Item 5
MCPB
3/10/05

MEMORANDUM

REVIEW TYPE: Site Plan Review
APPLYING FOR: Approval of 13,638 gross square feet of commercial development of which 8,910 square feet is new construction and 4,728 square feet is existing commercial space to be retained; 6,819 square feet constitutes FAR density, with the remainder as cellar space

PROJECT NAME: 8215 Fenton Street
CASE #: 8-05021
REVIEW BASIS: Montgomery County Zoning Ordinance, Div. 59-D-3,
Site Plan required for the Fenton Village Overlay Zone, §59-C-18.19
Allowance for reduction in required setbacks per §59-C-6.236(d)(4)

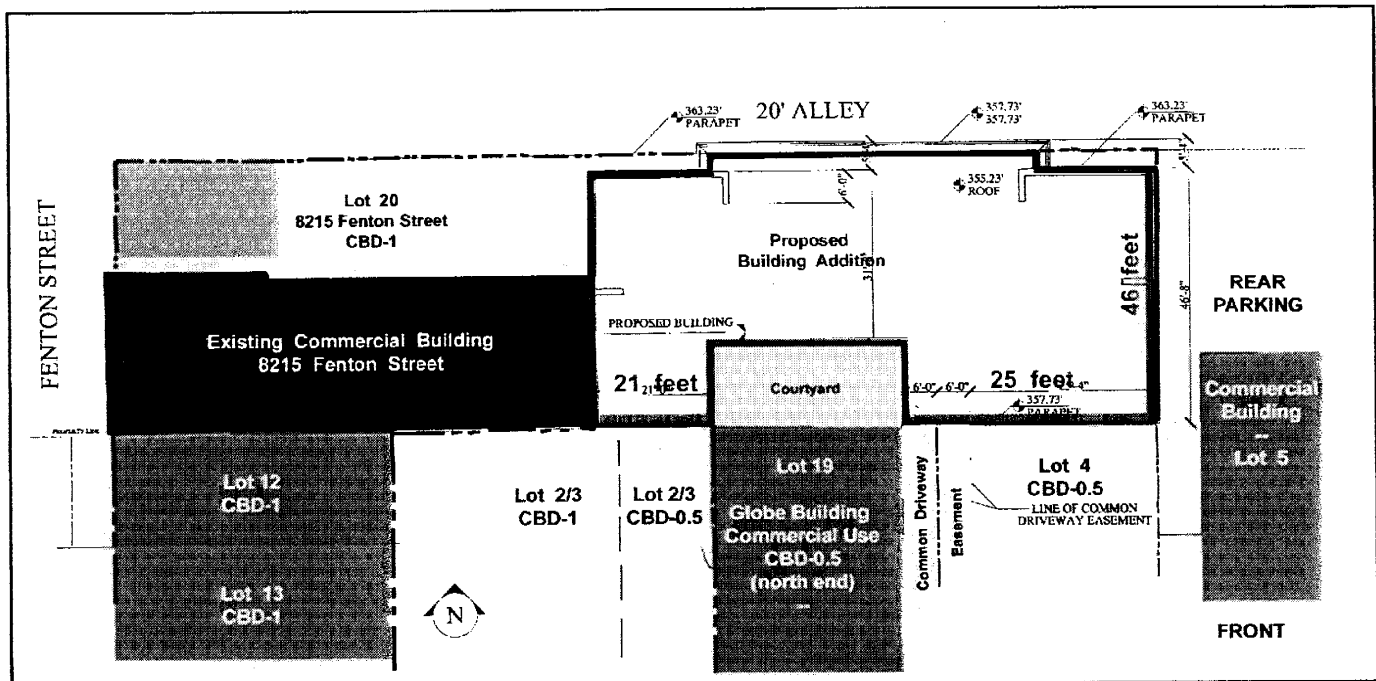
The southern façade of the existing structure on the subject site is constructed along approximately 35 feet of the north property line of Lot 2/3. The subject site plan proposes to extend the structural plane for the length of the Lot 2/3, or 21 feet, to the western edge of the Globe Building; thus, the request for reduction in setback corresponds to the proposed wall extension.

An interior open-air courtyard, approximately 36 feet in width, is proposed to provide a 15-foot setback adjacent to the Globe Building's north building façade, also the north property line of Lot 19. The building elevation that directly faces the Globe Building features proportioned, unitized fenestration with windowless wing walls. The applicant seeks a reduction in the 15-foot setback requirement for six linear feet along the common property line at the eastern edge. This six-foot strip functions as part of a shared driveway easement that is used by the tenants of Lot 19 for access to the first floor parking garage and for access to the rear of Lot 4.

The building design features the continuation of the south façade along the adjoining property line of Lot 4 and Lot 5. The elevations are proposed as windowless facades, intended to create the typical interior block "party wall" relationship with future development of Lot 4. The existing structure on Lot 5 features an egress door facing the proposed building's windowless elevation on the east.

Staff supports the proposed reduction in the building setbacks from Lot 2/3, Lot 19, Lot 4 and Lot 5, per §59-C-2.623(d)(4) and finds that the proposed development meets the intent of the CBD-1 zone and the Fenton Street Overlay Zone. The proposed development meets the standards for compatibility with no detrimental effect.

Sectional drawing showing the proposed building addition and the Globe Building. The rear-to-rear relationship is accommodated by

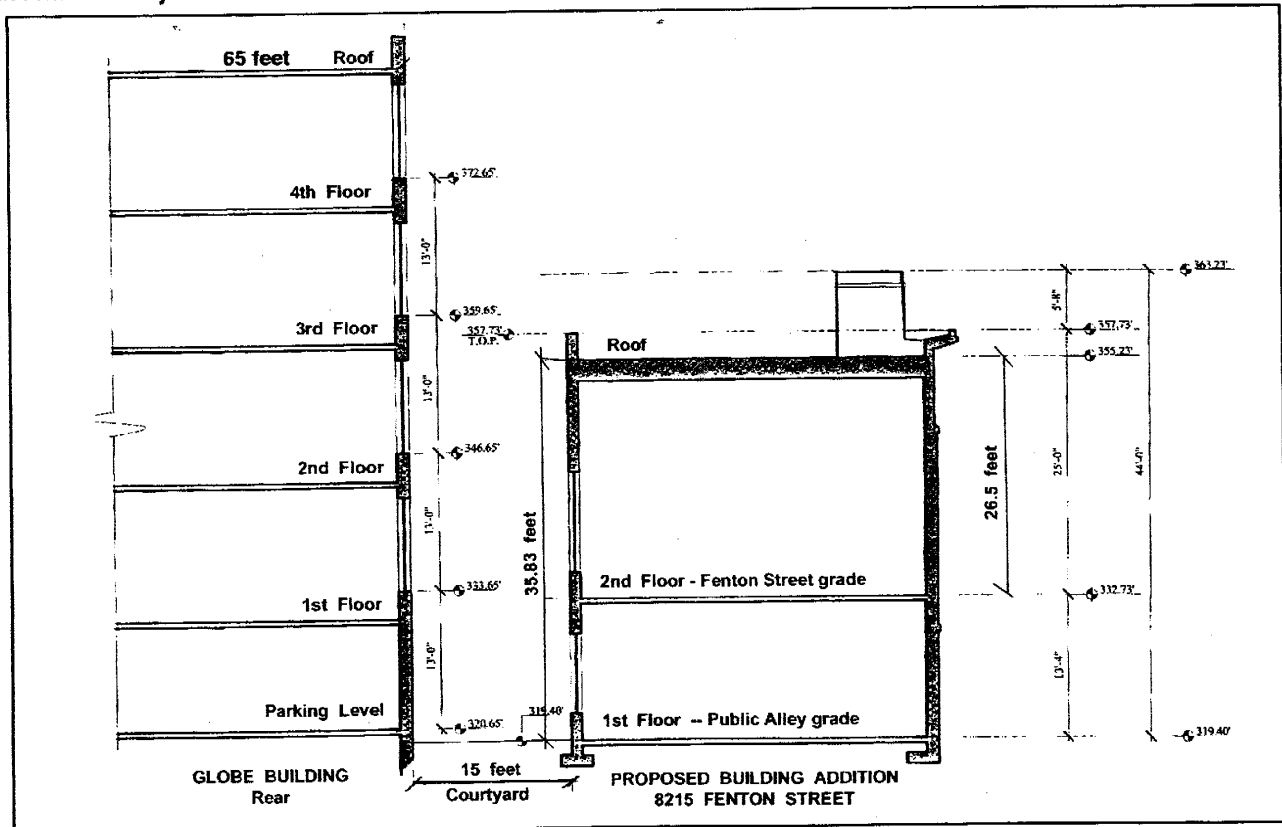
- The Zoning Ordinance provides for flexibility in setback requirements for CBD Zones, subject to Site Plan review;
- Site conditions in the CBD zones are frequently optimized by structures built to the lot lines with continuous building walls;
- The height of the proposed building is limited to 26.5 feet as measured from Fenton Street grade; the small brick parapet walls on the building front along the public alley extend only 8 feet above the roof line;
- The design provides for the 15-foot setback adjacent to the Globe Building by means of the interior courtyard featuring fenestration.

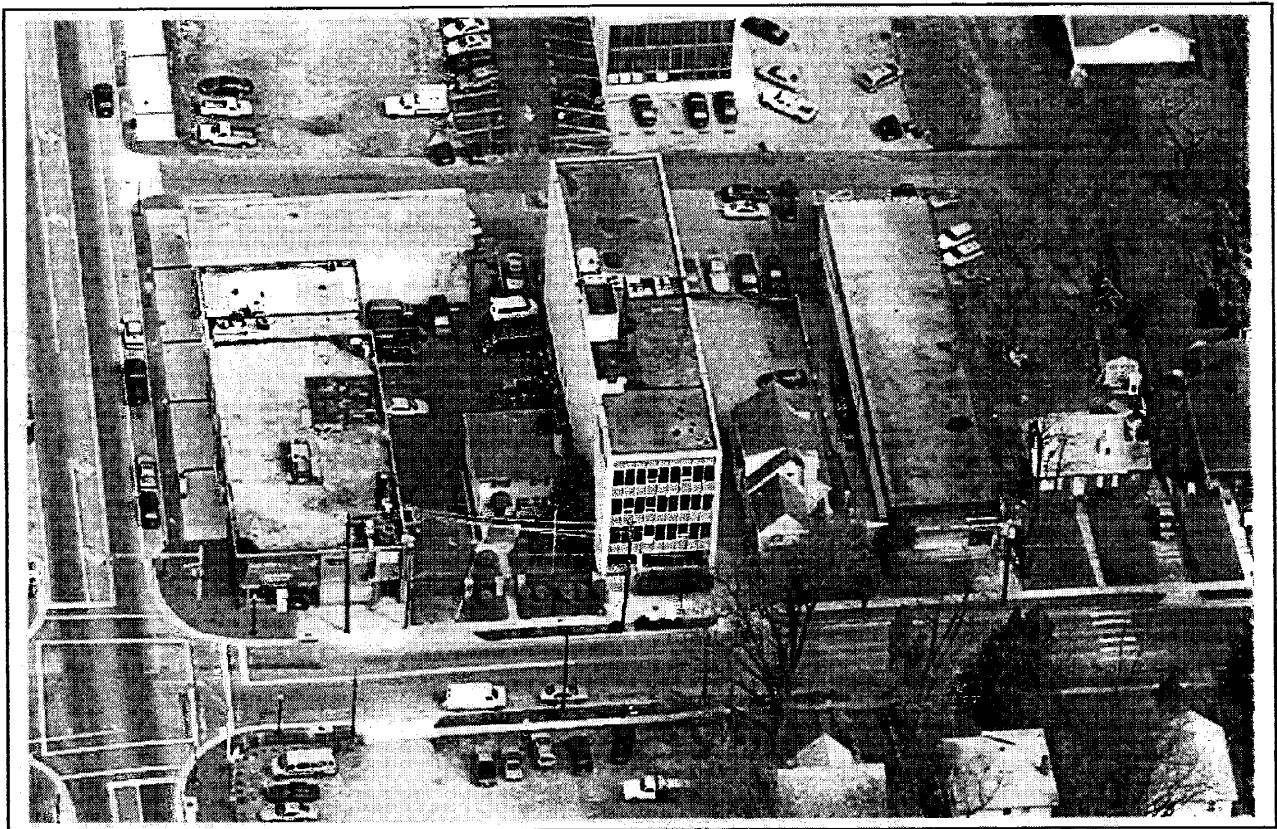
The adjacent property owner of the 5-story Globe Building has expressed objection to several aspects of the proposed building design because of his concern that the height and rear building line of the development would block the windows of the Globe Building (Lot 19) from receiving adequate light, air, and ventilation. The owner has stated that the new, 2-story building addition would cast shadows on his building, attributable to the height; additionally, the owner has stated his objection to the applicant's request for reduction of setback from the adjoining rear property line based on his opinion that the proposed courtyard featuring a 15-foot setback is too small to provide adequate light and ventilation and to mitigate the effects of the 26-foot building height.

With respect to the Globe Building (Lot 19): The building, constructed in the 1960's, far exceeds development standards currently allowed: the building footprint extends fully to the lot line on the west (and about 8 feet from the adjacent house); and on the north adjoining the subject site (Lot 20) the building footprint also extends to the lot line. At the street frontage on Silver Spring Avenue, the building footprint extends to within about 5 feet of the right-of-way; on the east the building footprint extends to within 6 feet of the east property line (and about 10 feet from the adjacent house), necessitating the shared driveway easement for site ingress. Building coverage represents more than 75% of the lot area and the building rises to a height of 65 feet (approximately). The Globe Building, if proposed today, would require approval of a reduction in setback for the 34 feet of its façade that adjoins the subject Lot 20 and would be limited to a height of 45 feet.

Finally, the affected façade of the Globe Building is the north elevation that receives minimal direct sunlight, if any; additionally, this exposure comprises the rear façade of the building that in its current state, faces an alley used for parking. The ground floor of the Globe Building, hence, a portion facing the proposed interior courtyard, is used for structured parking. Staff finds that the interior courtyard proposed adequate addresses any issue of light and air.
